Product Change Notification: P-21-021936

General Product Description:
LOW PROFILE SLIM SAS X8, RECEPTACLE VERTICAL CONN.

PCN Low Profile Slim SAS X8 Receptacle

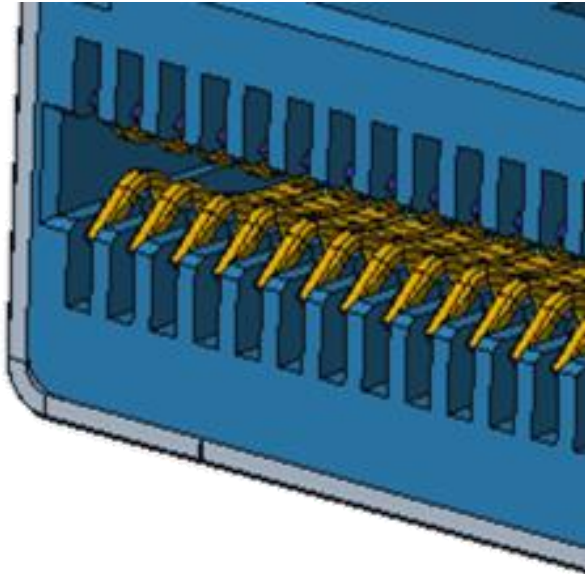
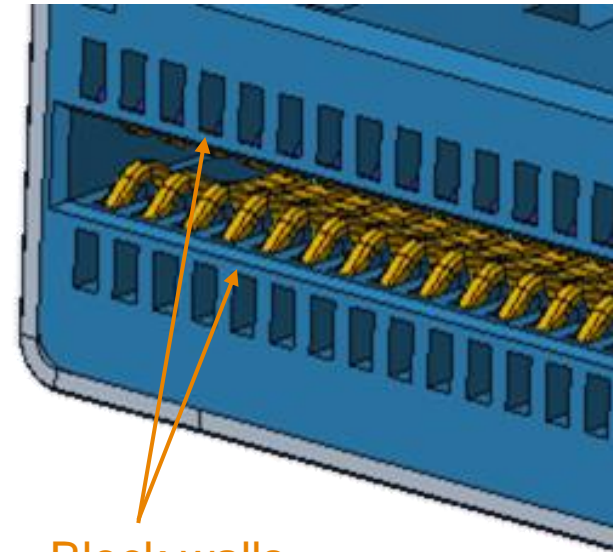
Adding block wall on housing opening of Low Profile Slim SAS V/T 8X. Making contact gap more stable to prevent pin damage that caused by paddle card.

- Adding block walls.

Block walls

With these changes update the customer drawing to revision 9.
